CITY OF RAYMORE

ADDENDUM NO. 1

West Hawk Ridge Improvements
Project #22-386-201

Addendum No. 1 - BID DATE REVISED - Question and clarification.

CITY OF RAYMORE RAYMORE MISSOURI	PARKING LOT LAYOUT PLAN	211082
HAWK RIDGE PARK WEST RAYMORE, MISSOURI		Sheet Number 09 of 18

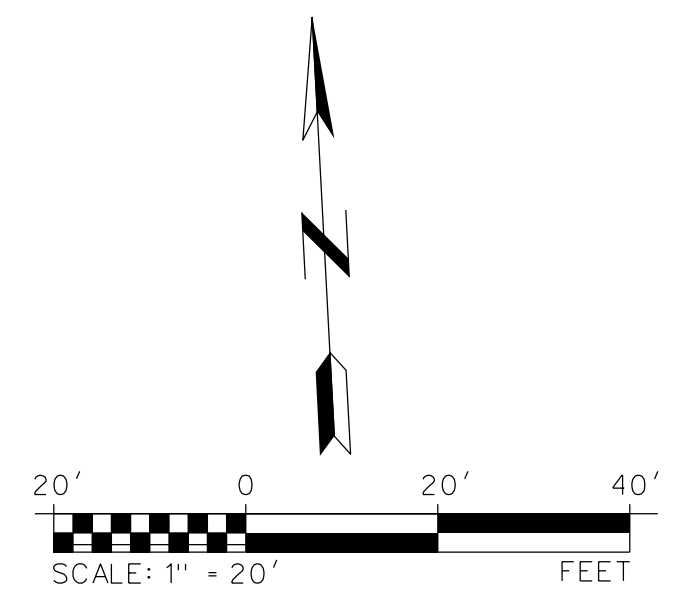
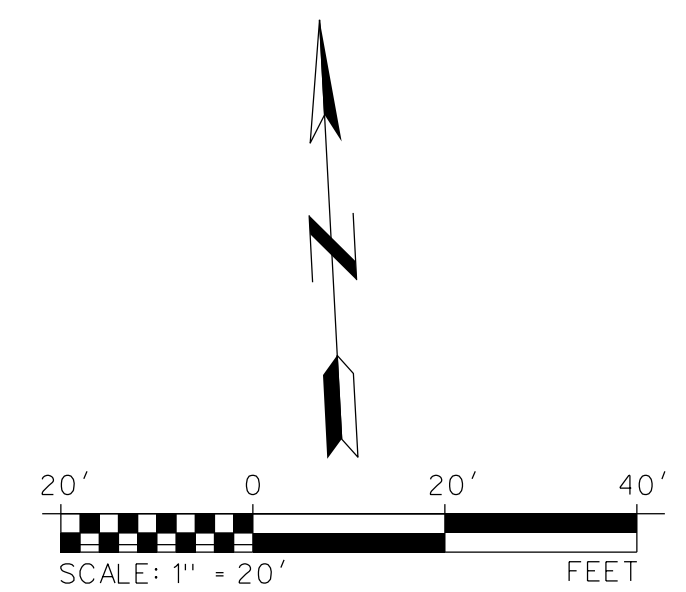
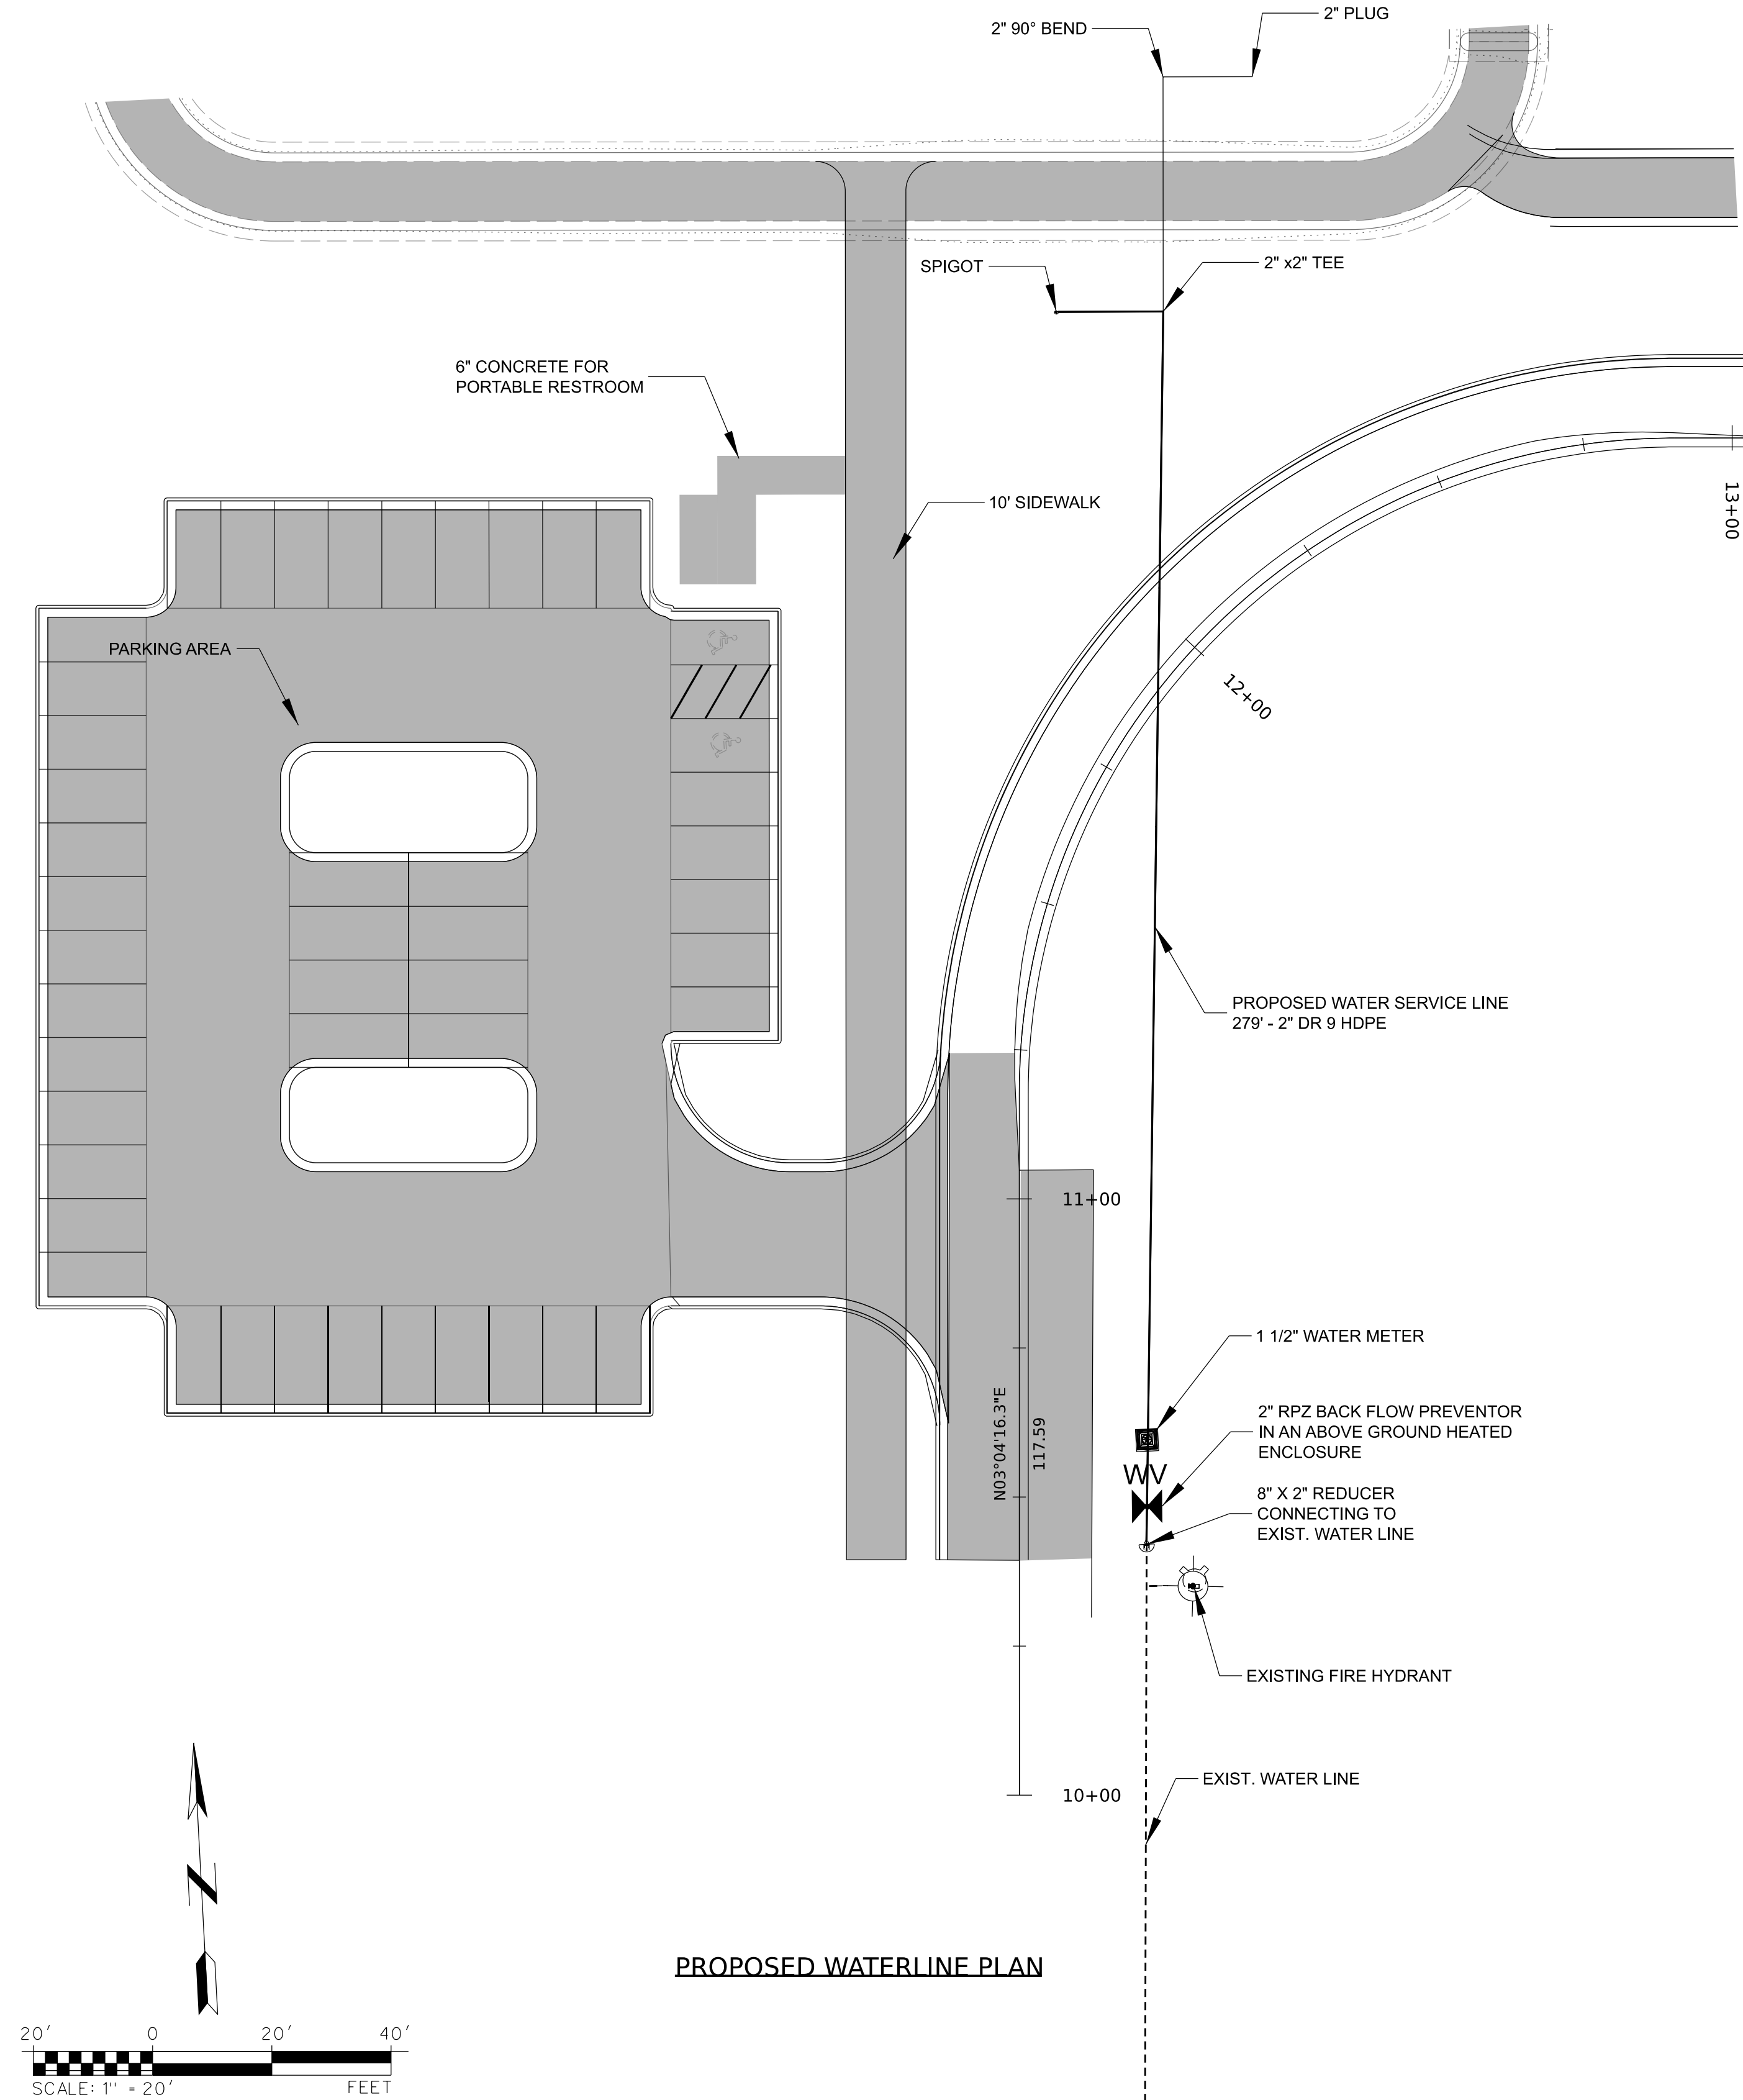
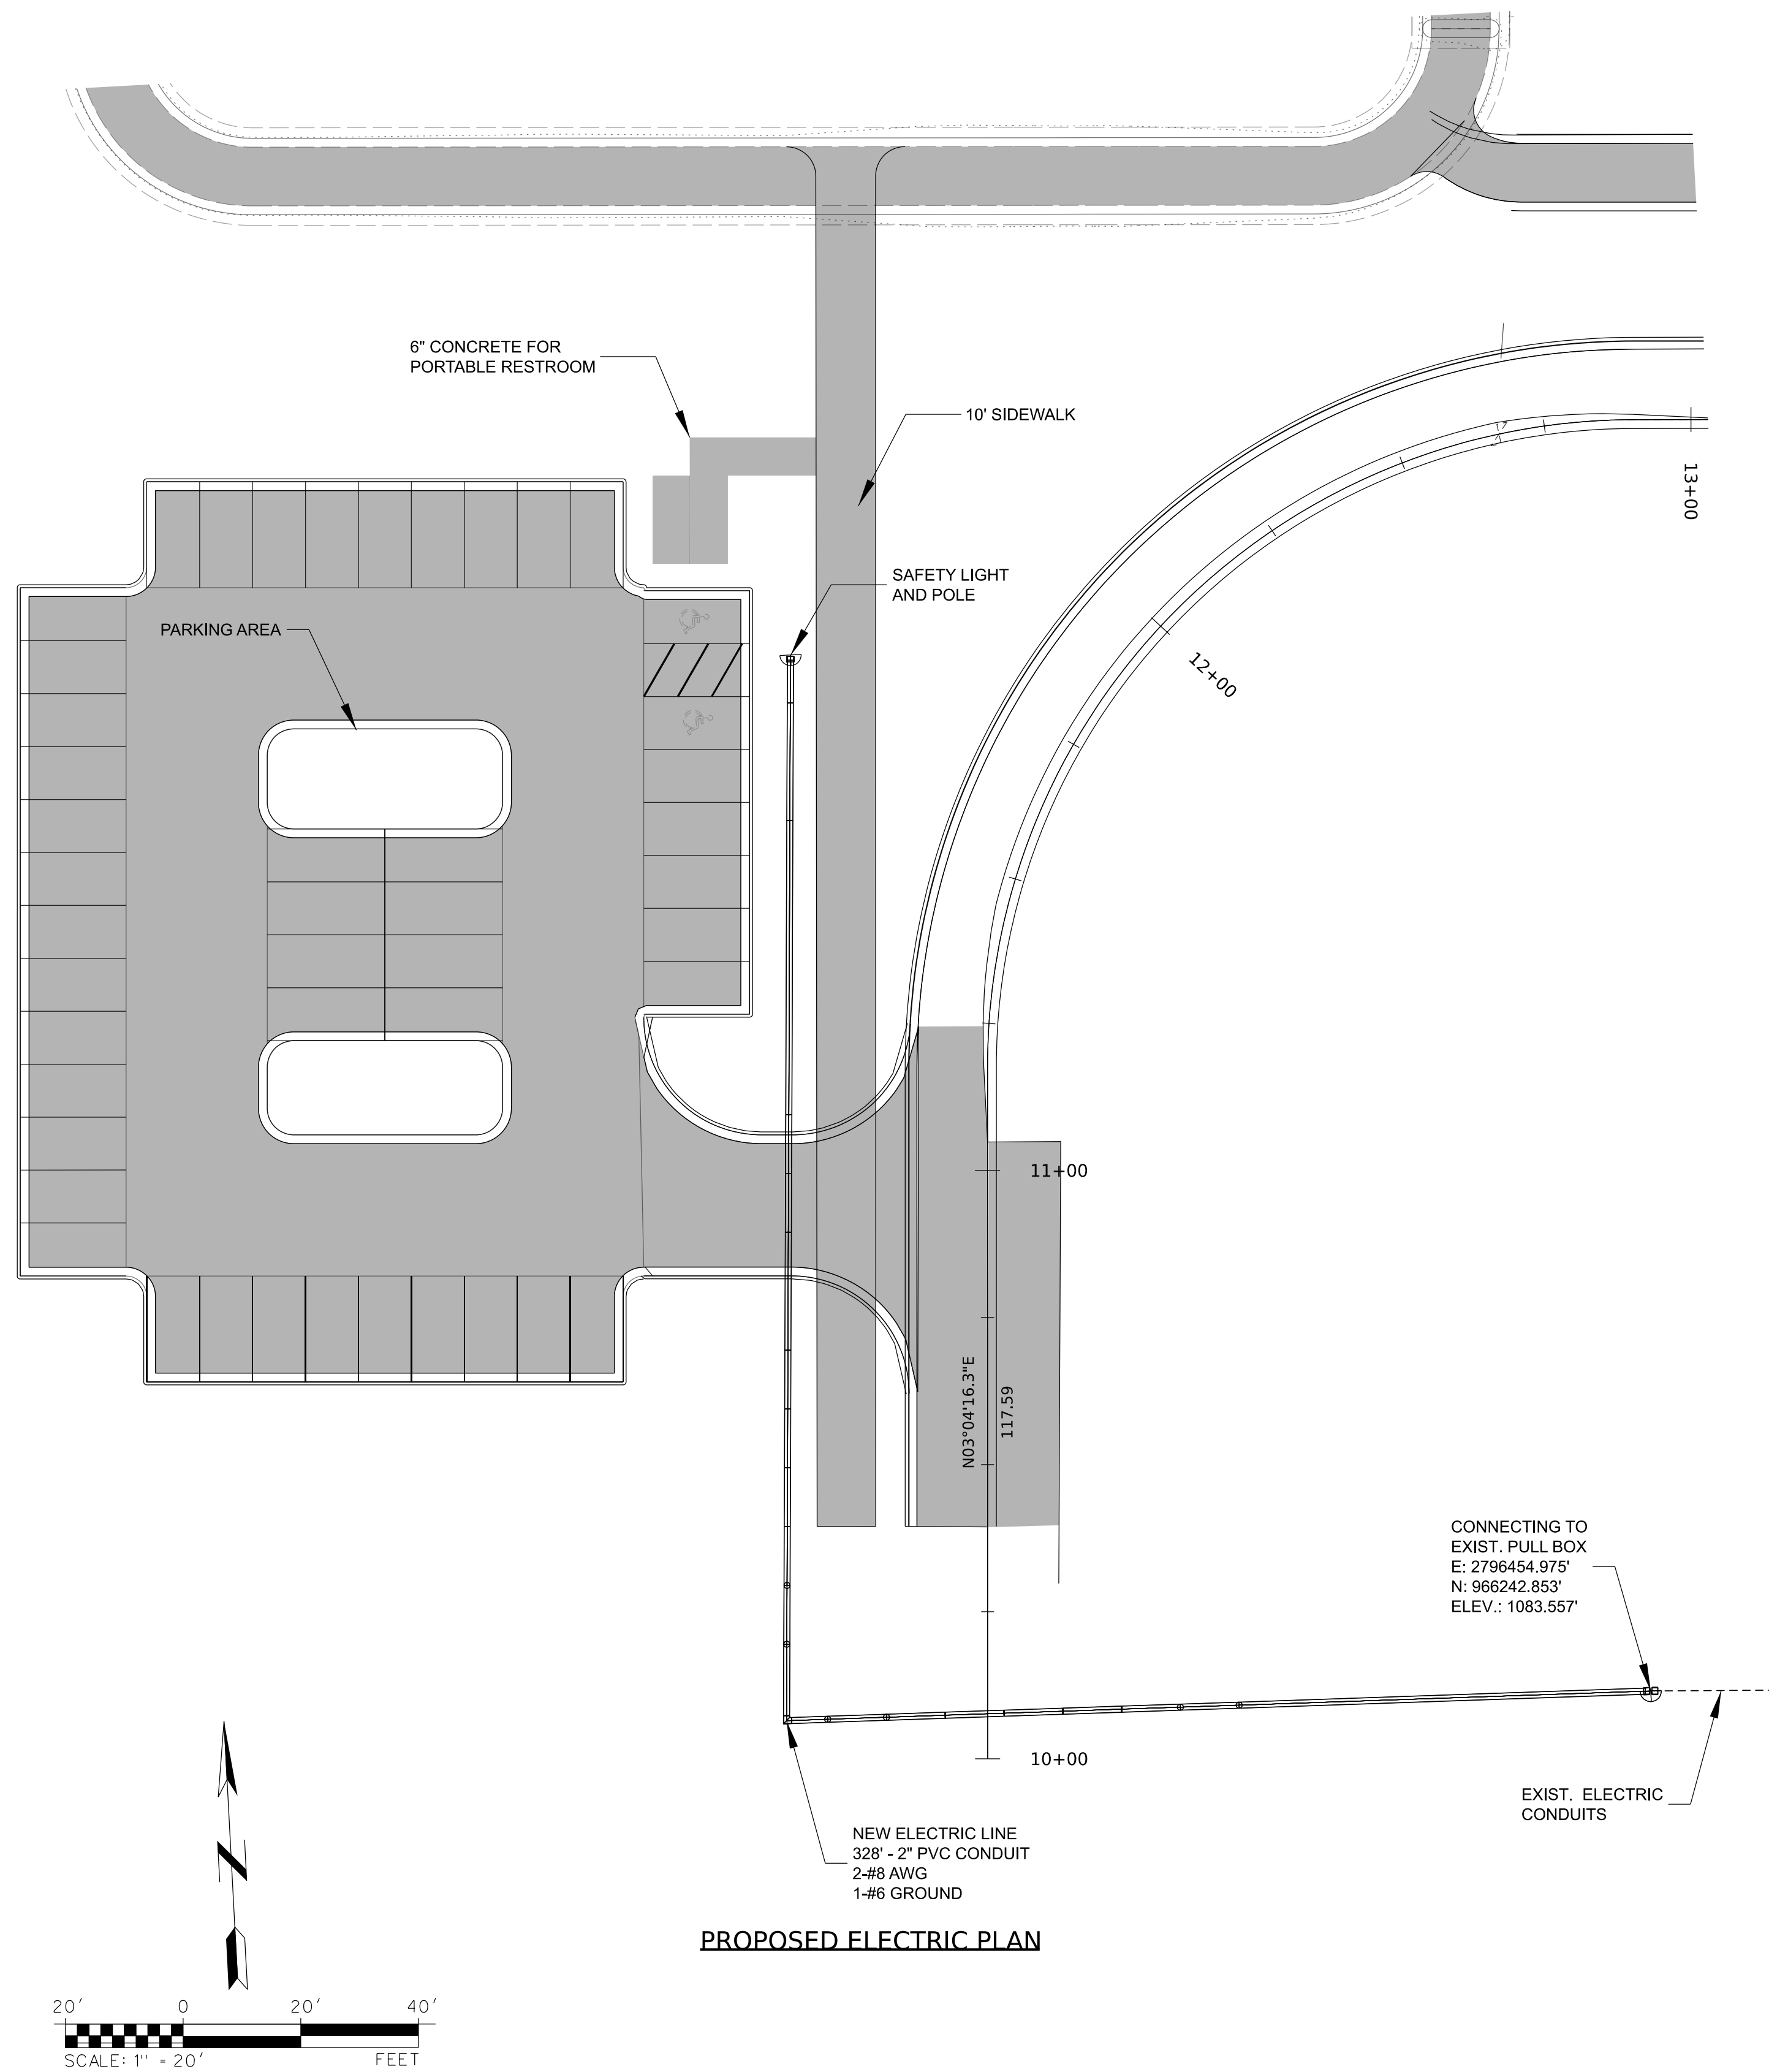
11. Question: The parking lot curb on sheet 9 of the plans scales off at 1.5' wide. Is this an error?

Answer: The level road_Curb_back was turned-off. Now, it is turned-on. Curb and gutter is 2' wide.
